ADDENDUM NO. 3

DATE OF ISSUANCE:	April 25, 2024
PROJECT:	2024 Addition and Renovations North Harrison Elementary School 1115 W. Whiskey Run Road Ramsey, IN 47166
OWNER:	North Harrison Community Schools
ARCHITECT'S PROJECT NO.:	23-228.001
ORIGINAL BID ISSUE DATE:	April 03, 2024

1
AD-3C

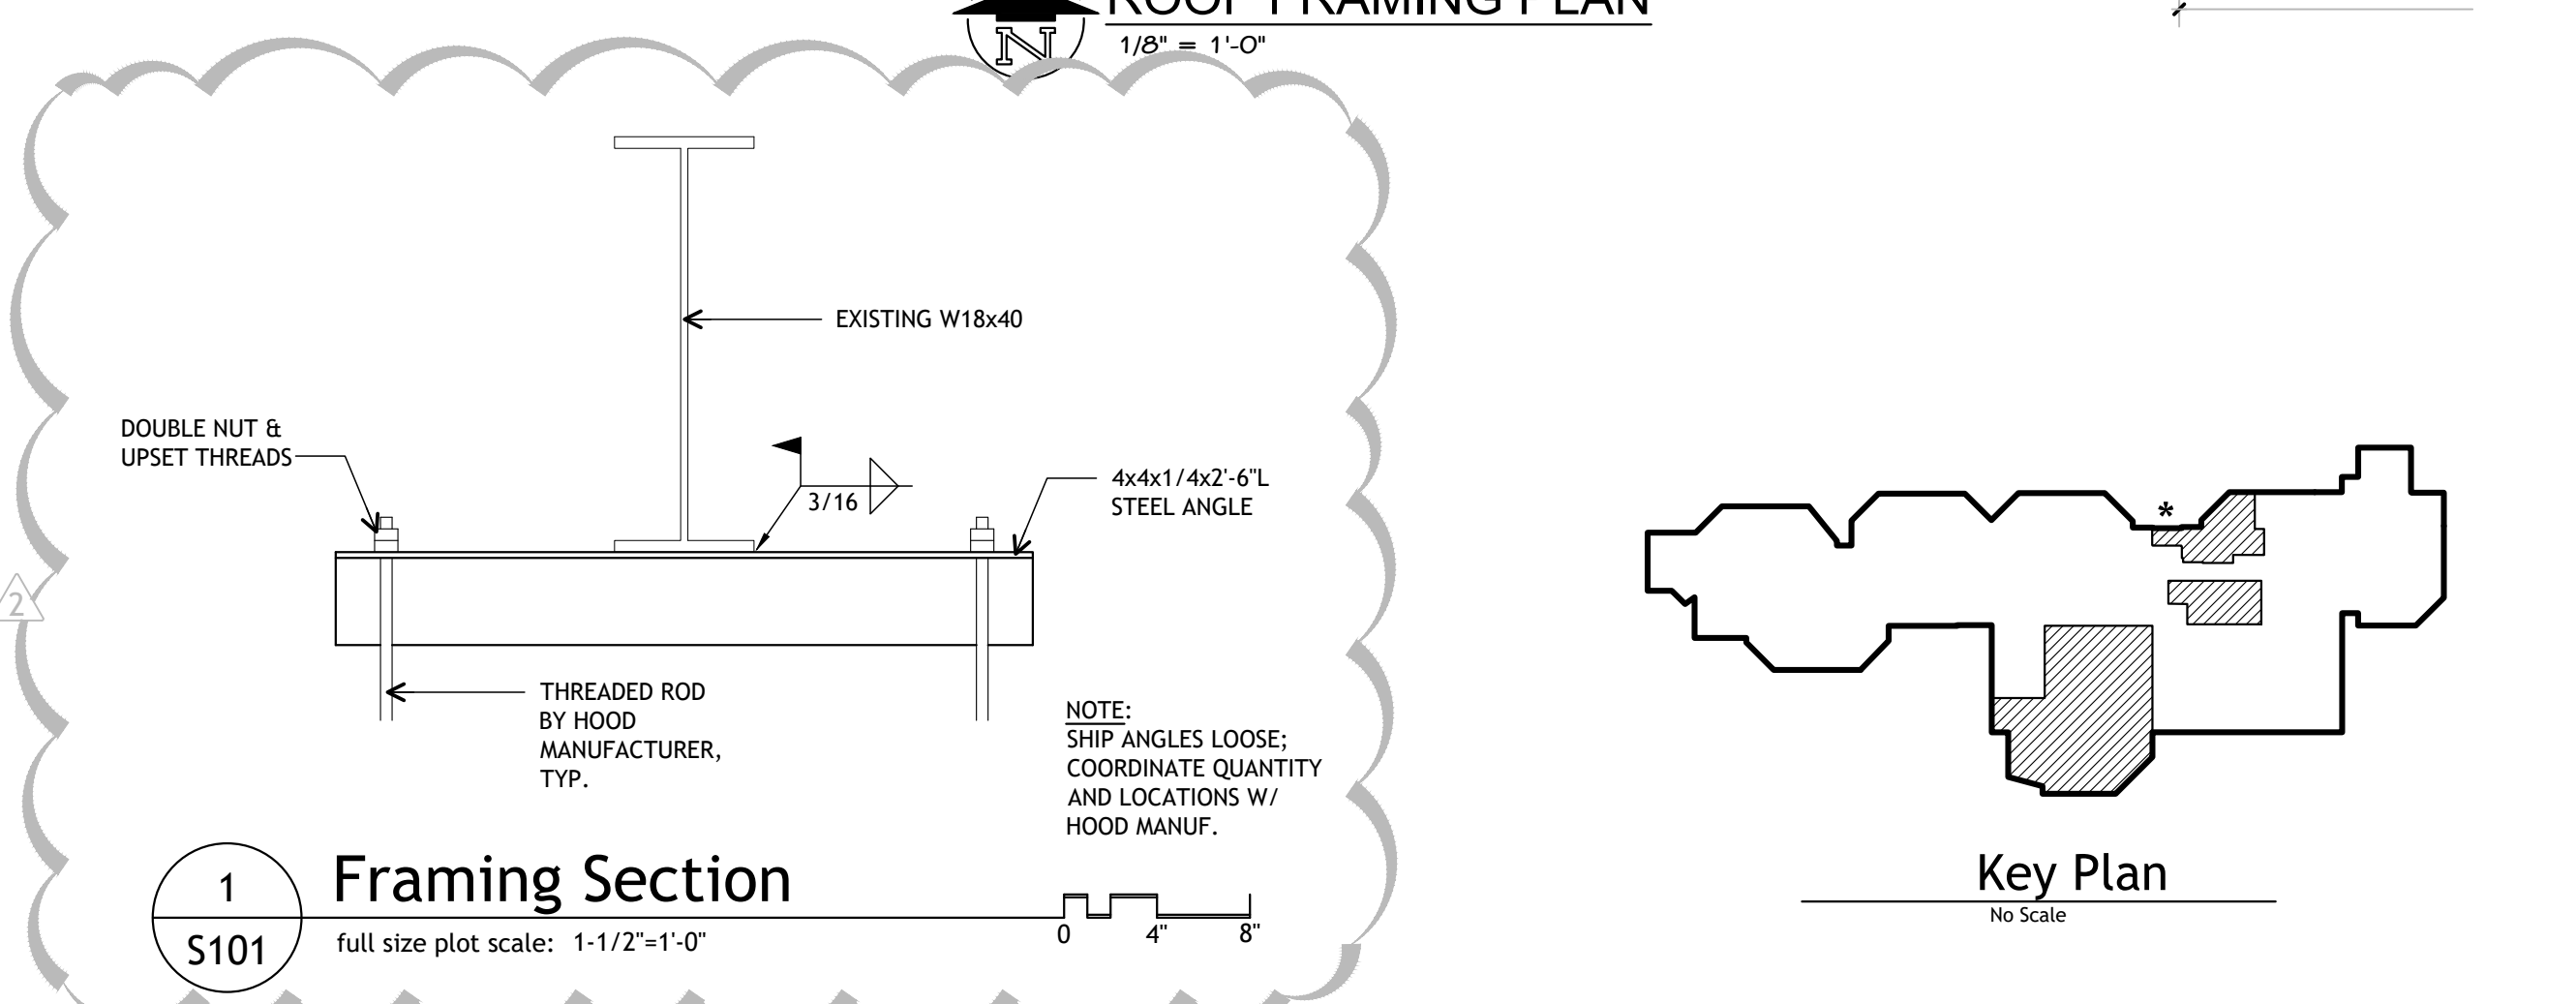
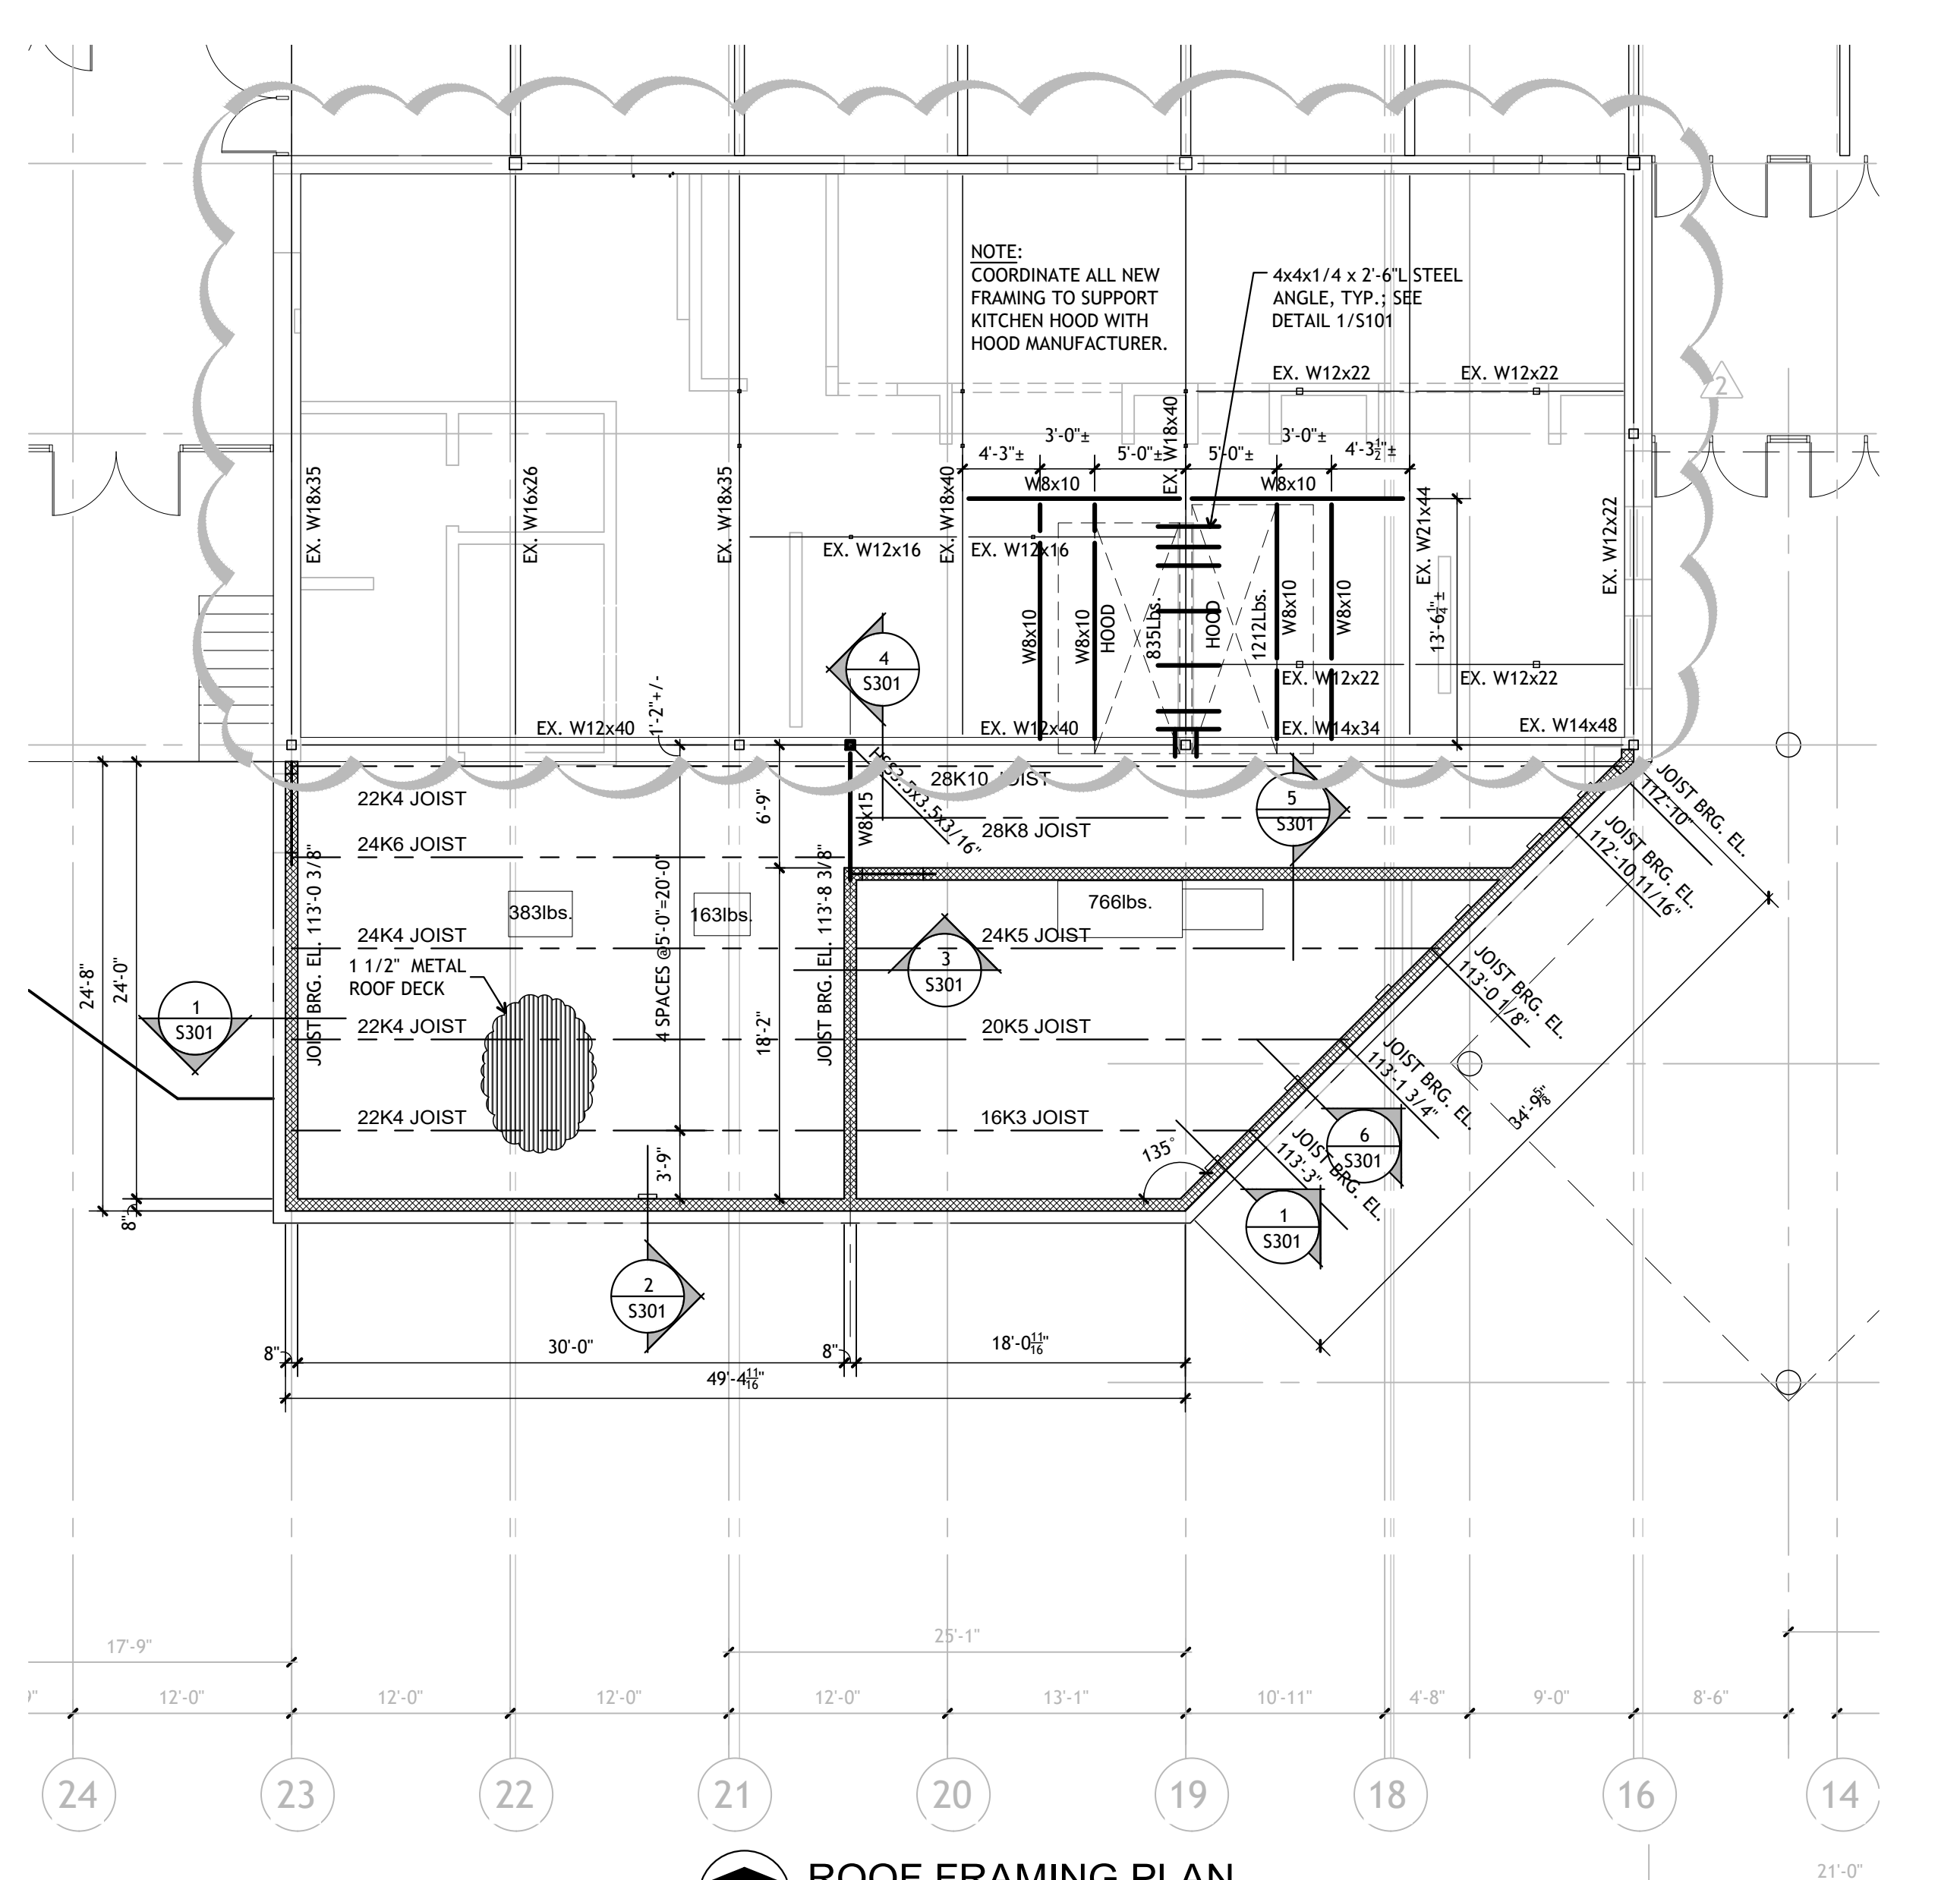
ADD-3 Item No. D-5 - Stair at Reception 103

Refer to Sheet(s): **A703**

Add attached Drawing AD-3C which includes a North-South architectural section through the stair.
